Access Compliance Report Public Rights-of-Way (Curb Ramps)

Main Street: ORANGE_PARK_BLVD Cross Street: ORANGE_PARK_BLVD Location: W

ADA ID: RPRK211222120319 Ramp Type: Type 4 - Parallel Initial Pass/Fail: Fail Overall Compliance: No Severity Score: 2

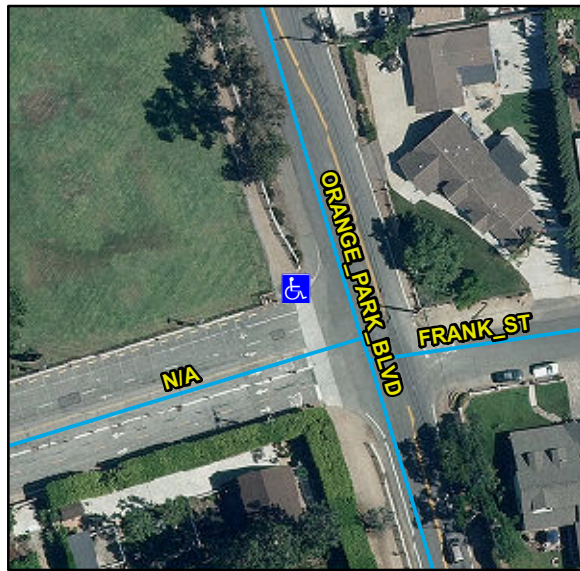
R304.5.3, STD 1115

Compliance	Description	Data	Compliance	Description	Data
N/A	Ramp Length LT (in)	92	N/A	Ramp Length RT (in)	87
Yes	Ramp Width LT (in)	61	Yes	Ramp Width RT (in)	61
Yes	Ramp Run Slope LT (%)	6	Yes	Ramp Run Slope RT (%)	6.5
No	Ramp Cross Slope LT (%)	2.7	Yes	Ramp Cross Slope RT (%)	0.1
N/A	Landing Present	N/A	N/A	DWS Provided	N/A
N/A	Landing Length (in)	N/A	N/A	DWS Contrast	N/A
N/A	Landing Width (in)	N/A	N/A	DWS Length (in)	N/A
N/A	Landing Run Slope (%)	N/A	N/A	DWS Full Width	N/A
N/A	Landing Cross Slope (%)	N/A		DWS Offset Type	N/A
N/A	Landing Movement Obstructed?	N/A	N/A	DWS Offset Left (in)	N/A
	Landing Movement Type	N/A	N/A	DWS Offset Right (in)	N/A
N/A	Landing Shared	N/A			
N/A	Clear Space	Yes			
N/A	Clear Space To Crosswalk (in)	N/A			
N/A	Marked Crosswalk 1	No	N/A	Marked Crosswalk 2	No
	Crossing 1 Direction	S		Crossing 2 Direction	E
	Marked Crosswalk 1 Width (in)	N/A		Marked Crosswalk 2 Width (in)	N/A
N/A	Ramp Inside Crosswalk 1	N/A	N/A	Ramp Inside Crosswalk 2	N/A

Remove & Replace Curb Ramp With Two New Directional Ramps or Equivalent.
